MATANUSKA-SUSITNA BOROUGH

REVISED PLATTING BOARD AGENDA ASSEMBLY CHAMBERS 350 E DAHLIA AVENUE PALMER

May 7, 2026

A. **MOUNTAIN TOP ACRES ADDITION 1:** The request is to eliminate a utility easement; to eliminate a common access easement; to create 35 lots from Lots 1-5, Mountain Top Acres, Plat #2024-80, to be known as **MOUNTAIN TOP ACRES ADDITION 1**, containing 39.9 acres +/- . The property is located north of N Sun Valley Drive, east of N Palmer Fishhook Road, and directly south of E Hatchers Landing Avenue (Tax ID #8529000L001-L005); within the NW ¼ Section 35, Township 19 North, Range 01 East, Seward Meridian, Alaska. In the Fishhook Community Council and in Assembly District #1. (*Petitioner/Owner: Bull Moose Surveying, Staff: Matthew Goddard, Case # 2026-009*)

<p>1 OF 1 SHEET</p>	<p>SCALE: 1" = 200'</p>	<p>DATE: 12/15/2025</p>	<p>PROJECT: 2025072</p>	<p>OVERALL DRAINAGE PLAN</p>	<p>MOUNTAIN TOP ACRES</p>	<p>FIELD BOOKS</p>	<p>DESIGN: 1</p> <p>STAMP: 1</p> <p>AS-BUILT: 1</p> <p>GRID: 1</p>		
No.	DATE	DESCRIPTION

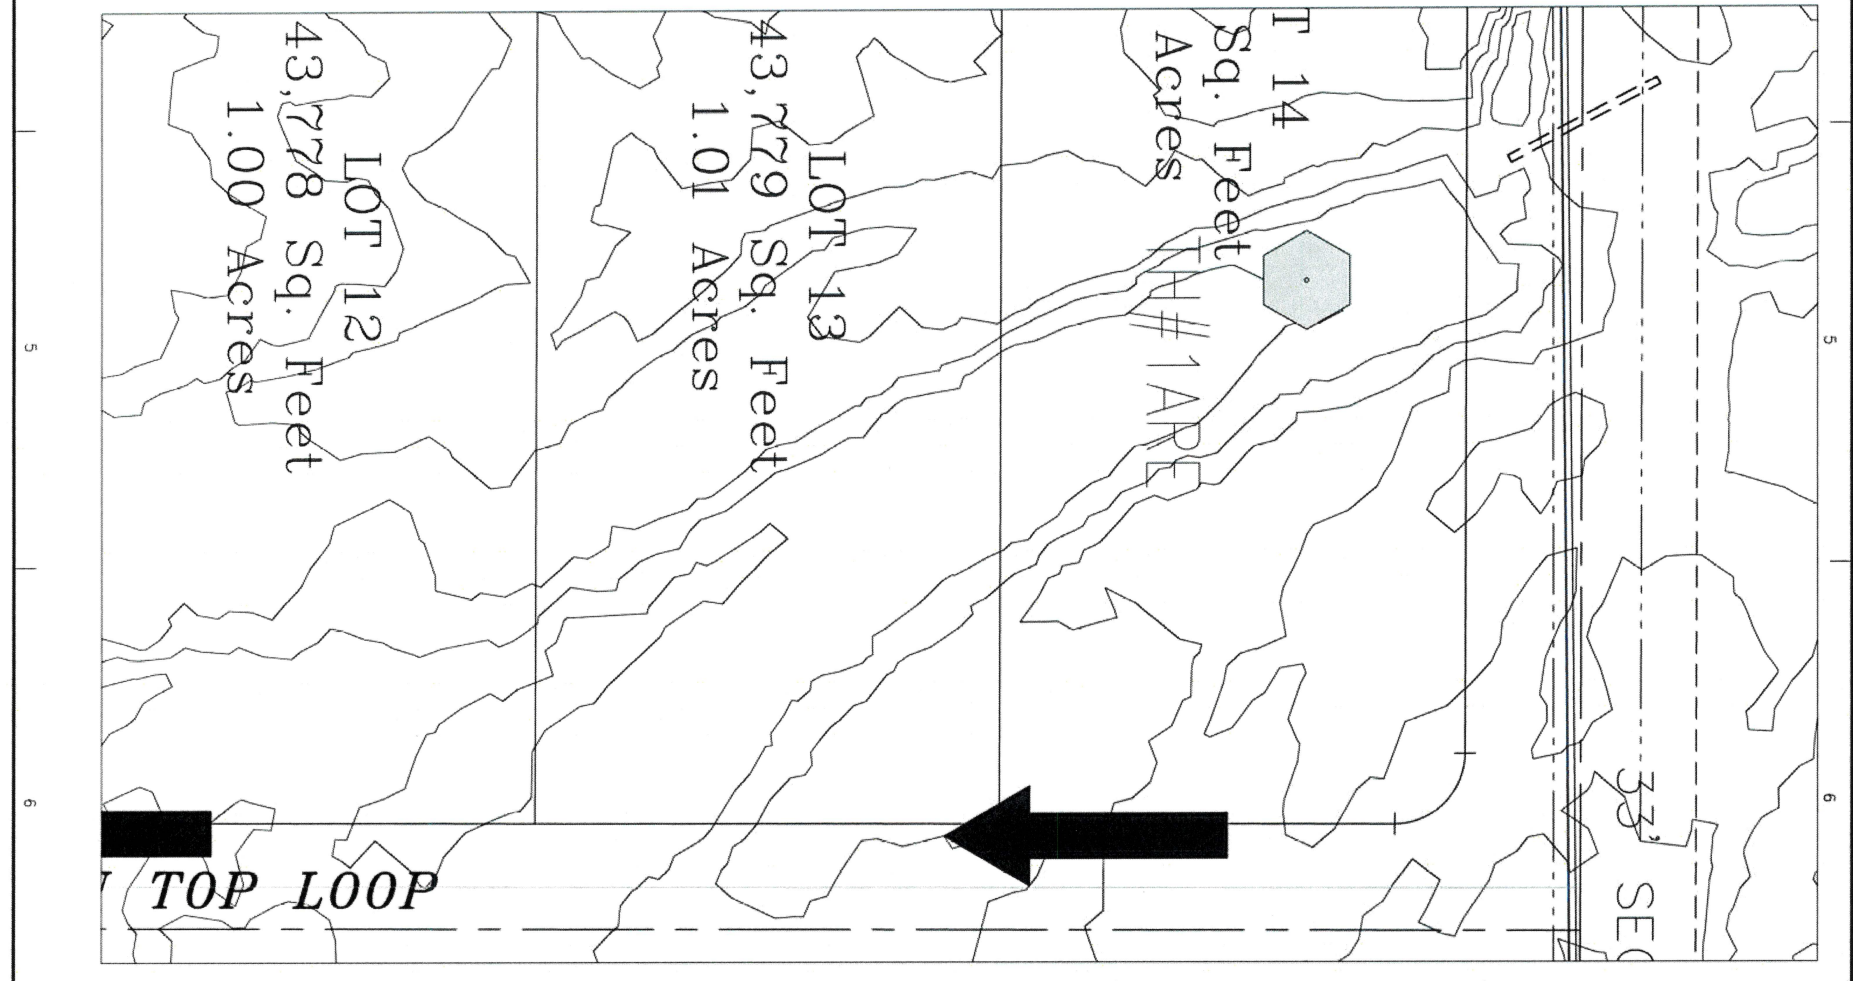
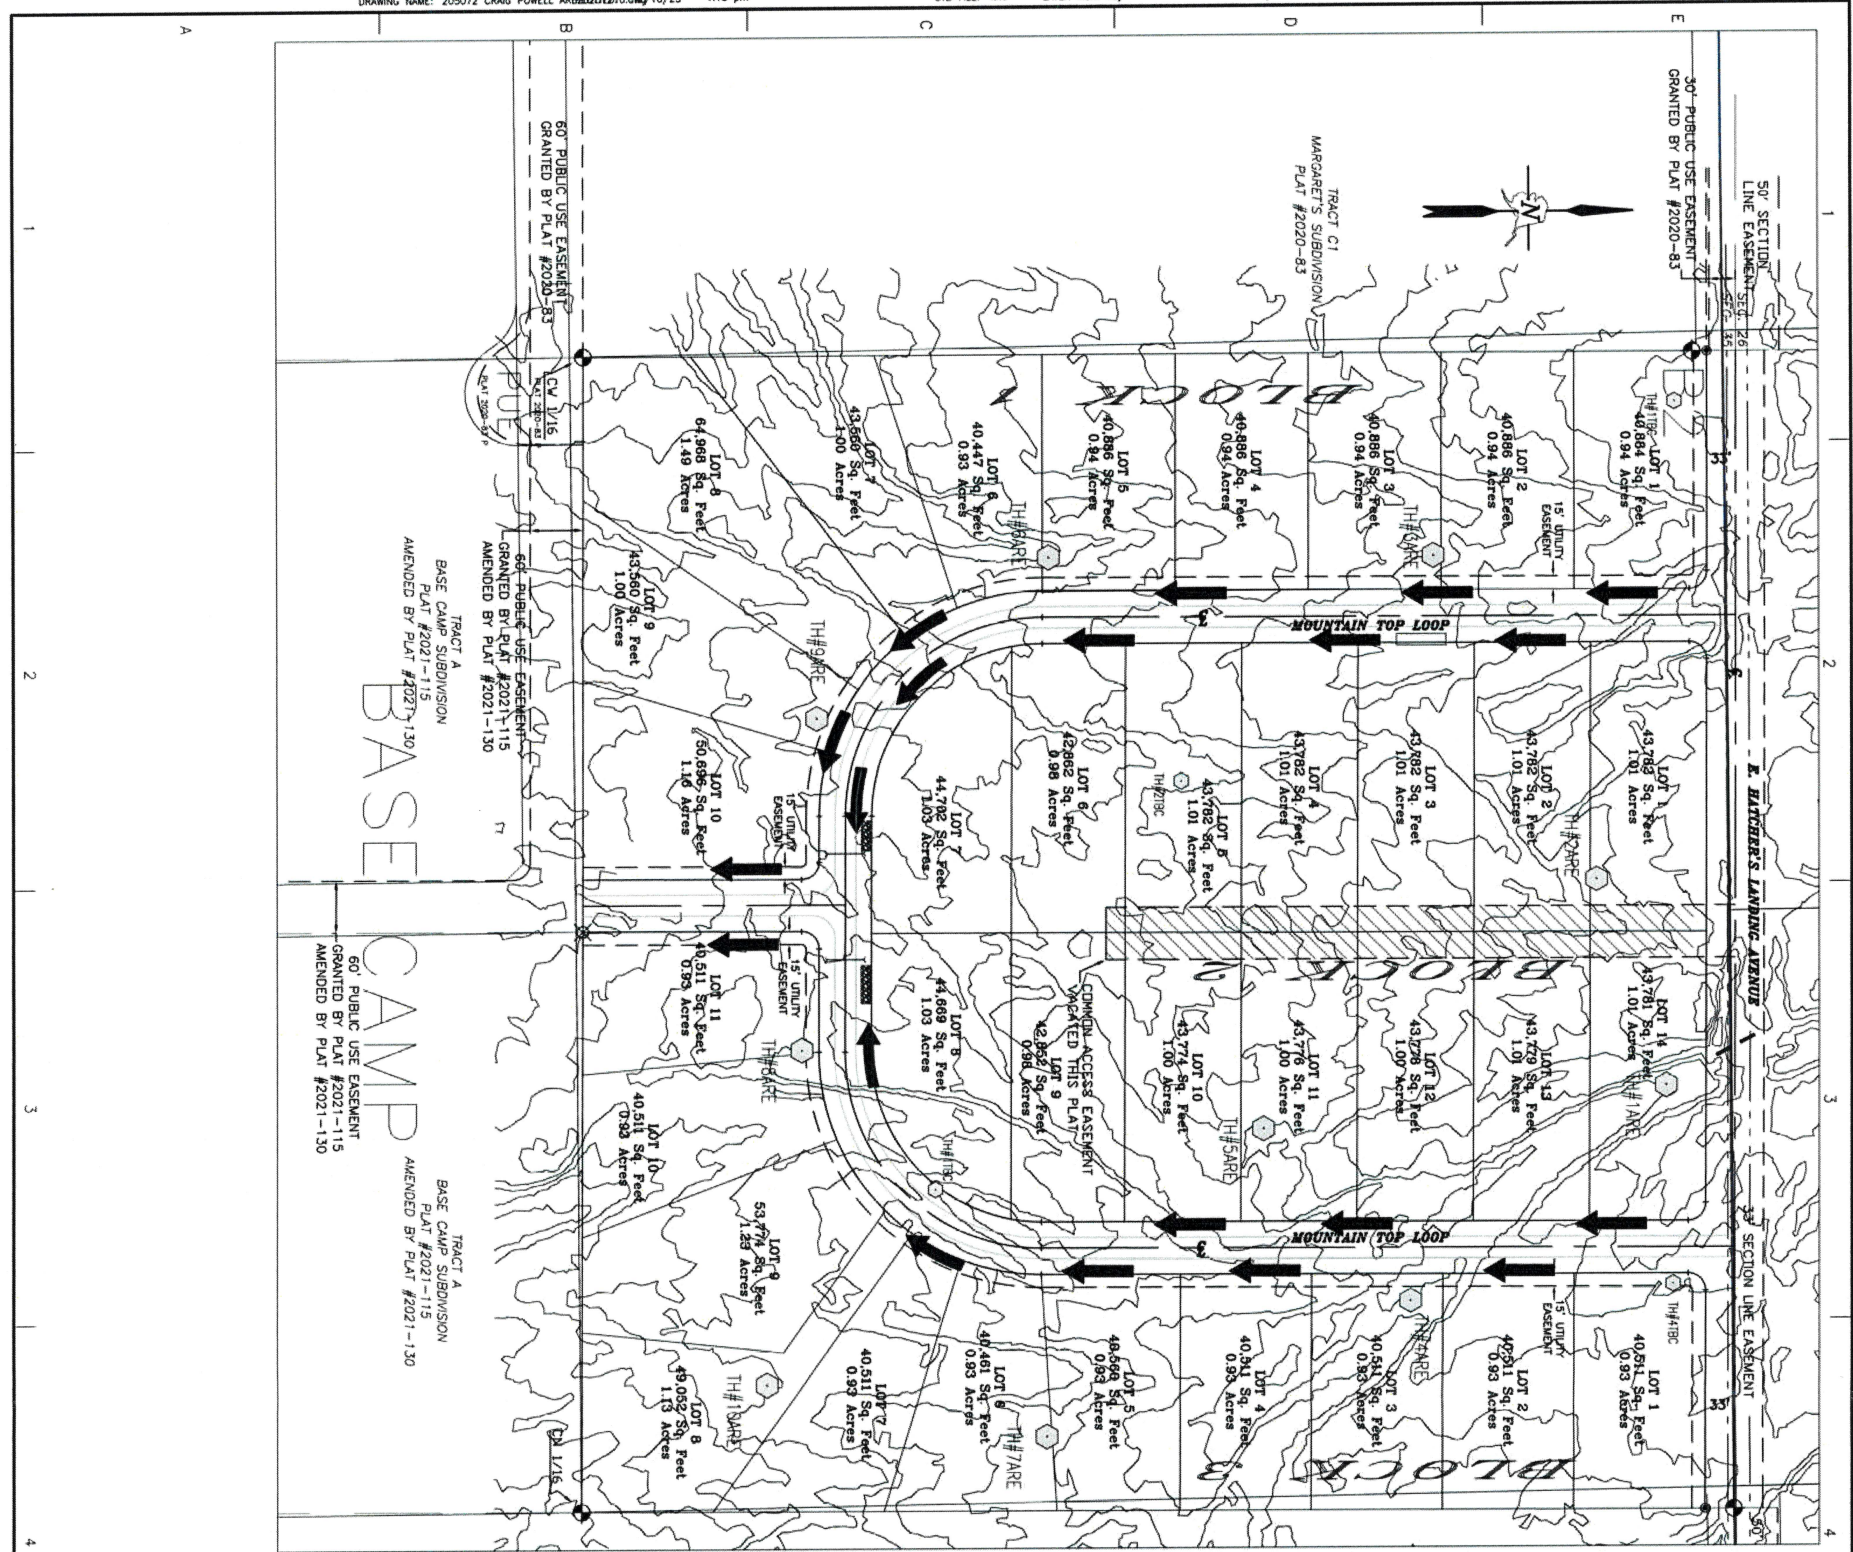
The drainage plan shows a natural drainage channel which crosses Hatcher's Landing Ave. through a 30" culvert and then being rerouted to the roadside ditches of Hatcher's Landing Ave. and Mountain Top Loop. Per 2022 Subdivision Construction Manual D03 natural drainage patterns should be retained to the extent possible and changes to drainage patterns must not adversely affect adjacent property or right of way. The drainage should be redesigned to keep the natural drainage channels through the subject property separate from the road drainage.

As I know you are aware, but for the petitioners' information, this will all need to be resolved prior to the NTP being issued -- not during construction. The part that the SCM does not provide much flexibility on is changes to where runoff enters and leaves the subdivision, and the provided drainage plan does both.

The drainage plan shows a natural drainage channel which crosses Hatchers Landing Ave. through a 30" culvert and then being rerouted to the roadside ditches of Hatchers Landing Ave. and Mountain Top Loop. Per 2022 Subdivision Construction Manual D03 natural drainage patterns should be retained to the extent possible and changes to drainage patterns must not adversely affect adjacent property or right of way. The drainage should be redesigned to keep the natural drainage channels through the subject property separate from the road drainage.

This new drainage plan appears to alter the natural drainage patterns even more. While details of the drainage design for subdivisions are often further developed/refined by the time the Final Drainage Plan and Drainage Report are submitted, the changes required for this drainage plan to meet the requirements of the SCM could be significant. We request the developer's engineer to reconsider the drainage design now so that they don't need to go back to the platting board if the lot and road layout need to change.

After speaking with Mr Leet, we are confident that the drainage ditches he is going to have in will be more than adequate to contain the drainage. While in construction we will review the drainage and make alterations but we are confident that lot layouts will not need to change.

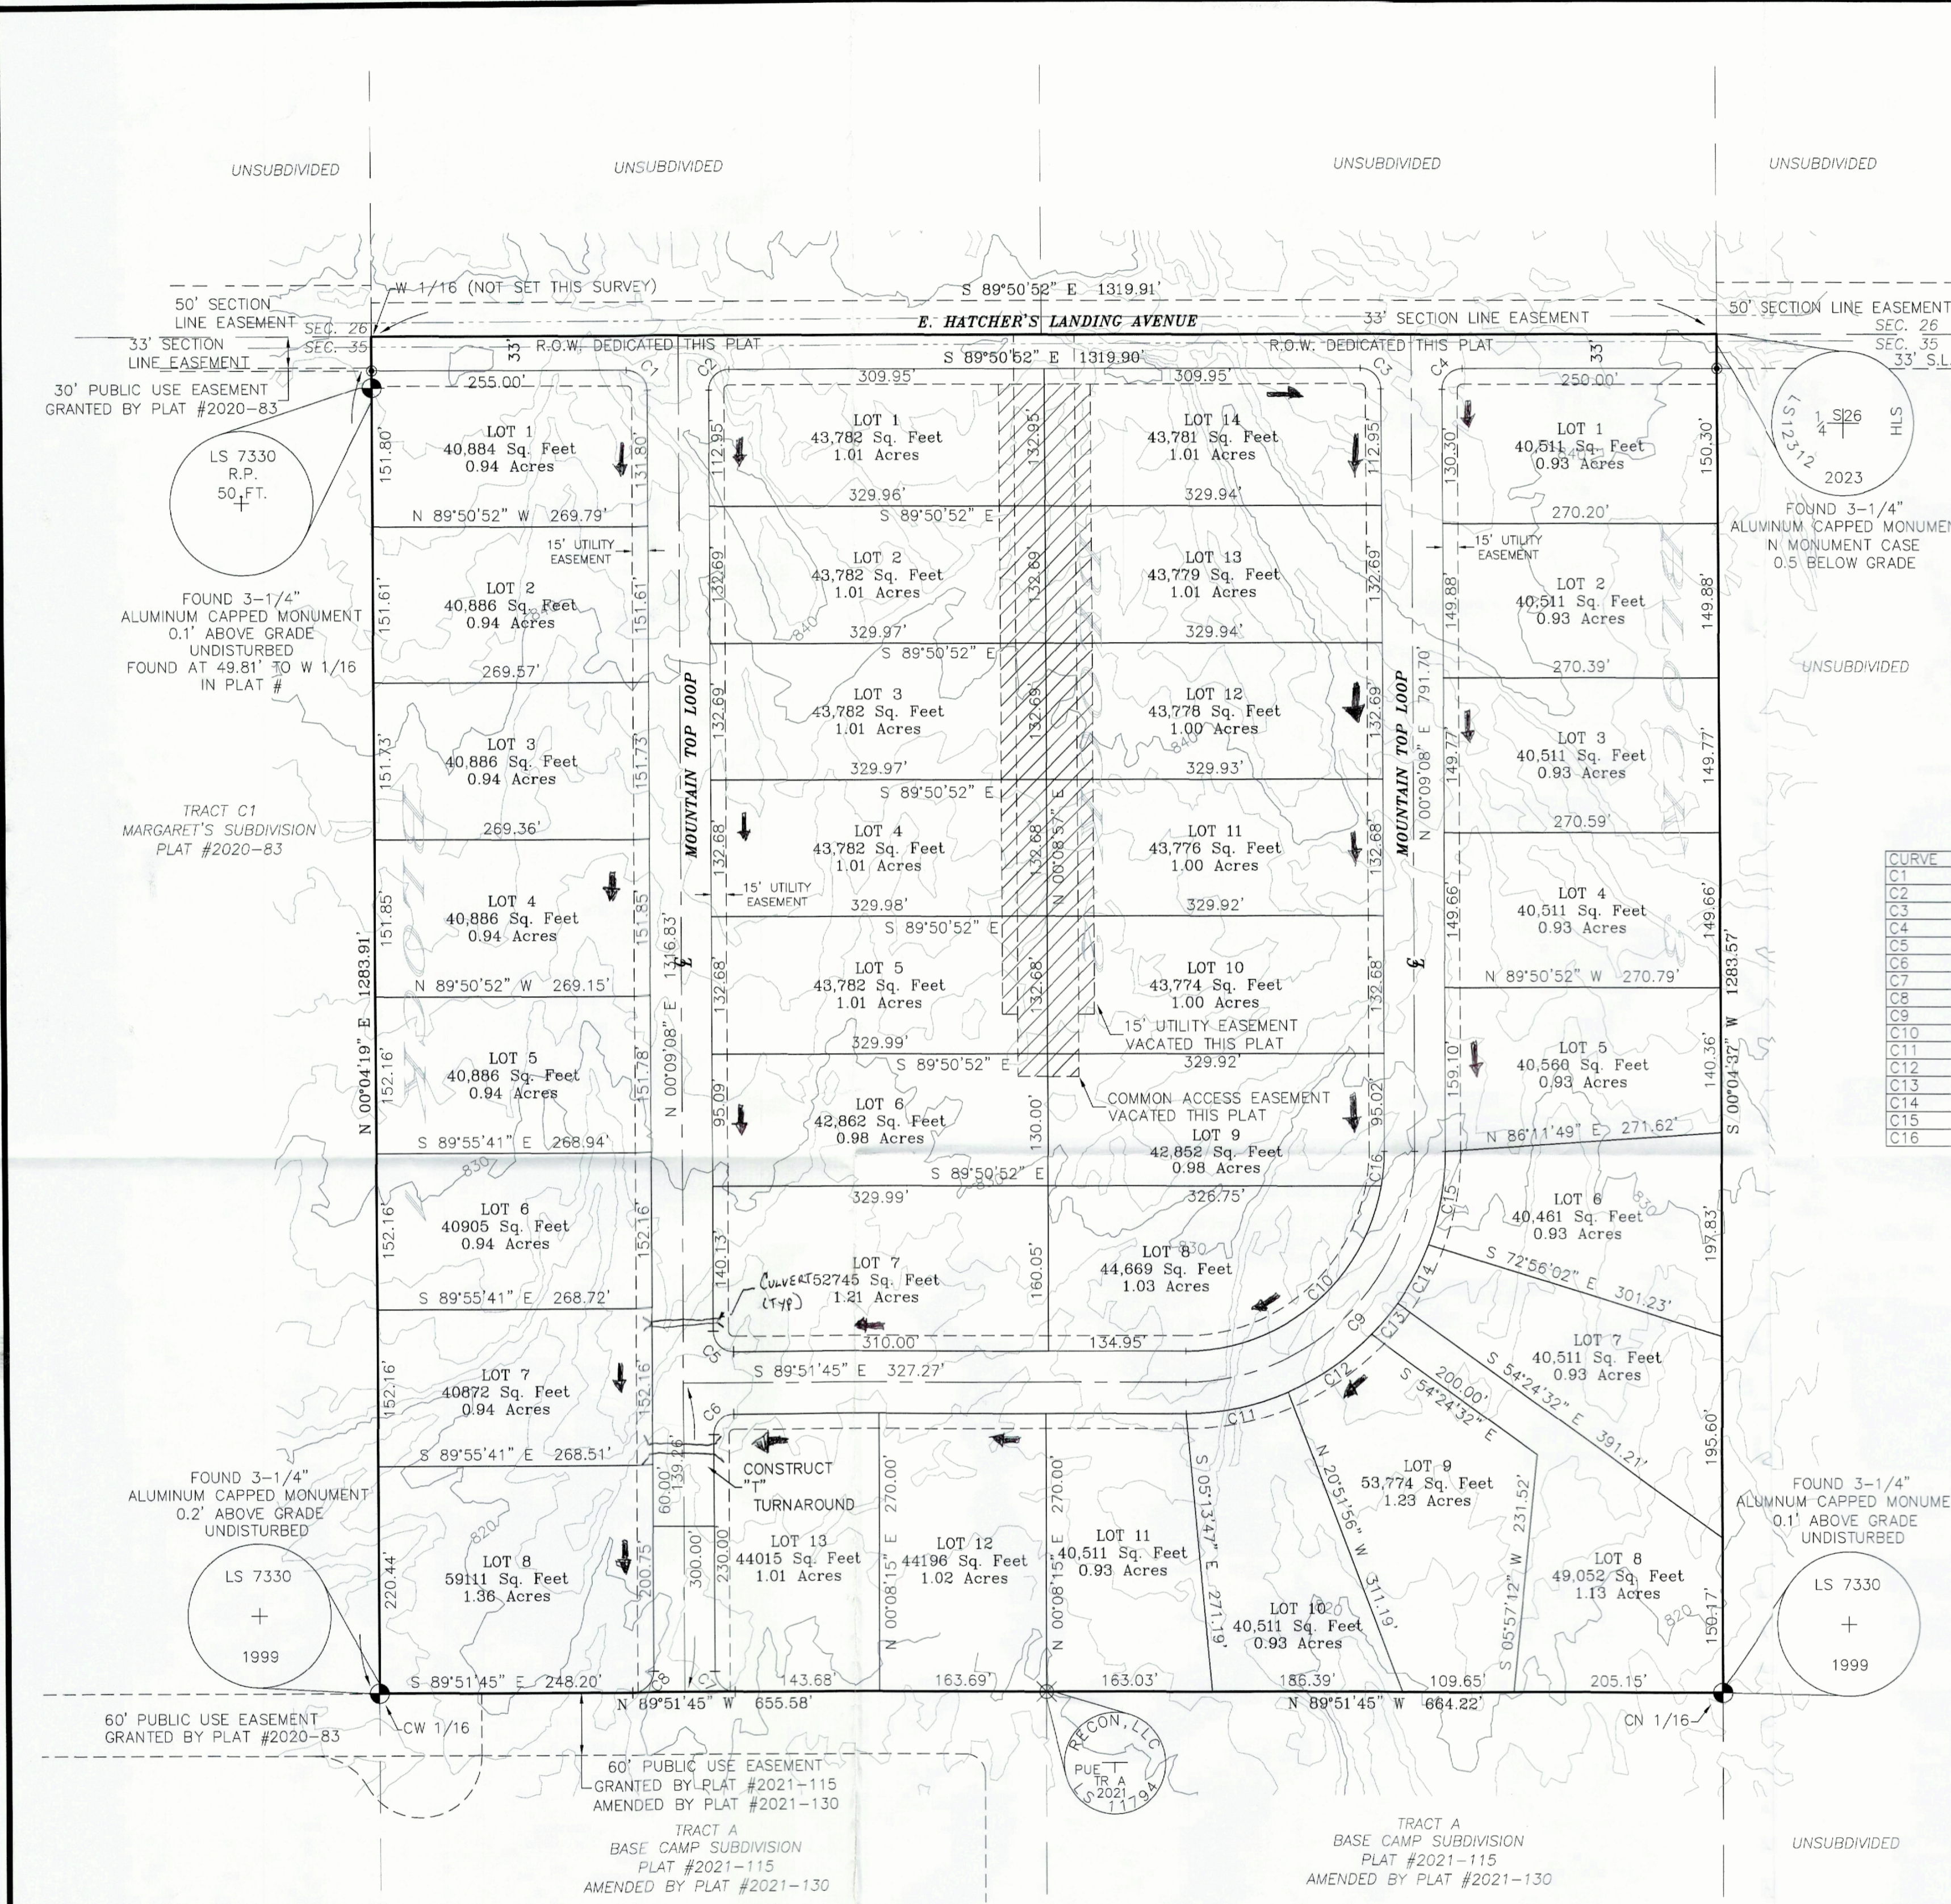
The summary states there will be 35 lots created to be known as Mountain Top Acres Additions 1; however the agenda plat calls out the lots (no block numbers) with there being 3 different Lot 1’s. Please clarify the lot numbers (or identify blocks).

The summary states there will be 35 lots created to be known as Mountain Top Acres Addition 1; however the agenda plat calls out the lots (no block numbers) with there being 3 different Lot 1's. please clarify the lot numbers (or identify blocks).

Staff notes that block numbers will need to be added during the final review process Recommendation #5).
